Urgent Field Safety Notice

SBN-CPS-2017-003

cobas[®] 8100 BRF and URF with Software Version 02-xx: Buffering May Cause Specimen Spillage

(Fig 1: English version of screen)

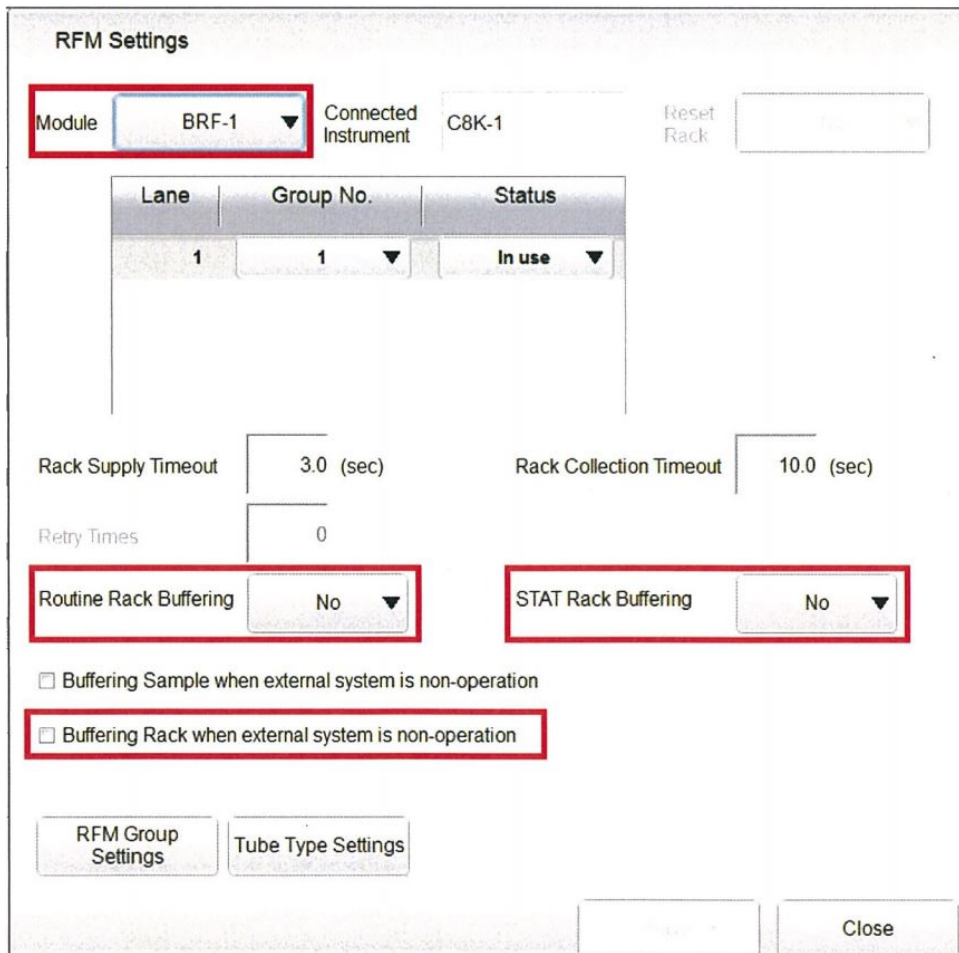
To prevent this issue, rack buffering has to be deactivated until the software is upgraded to version 03-01 onwards. Please refer to the following procedure to disable rack buffering:

- Open the RFM Setting Screen.
- Choose BRF and URF from the pull-down menu for "Module".
- Set "Routine Rack Buffering" to "No".
- Set "STAT Rack Buffering" to "No".
- Uncheck "Buffering Rack when external system is in non-operation".
- Press "Save" button.
- Repeat steps 2 to 6 for all connected BRF and URF modules.
- Reboot the system.
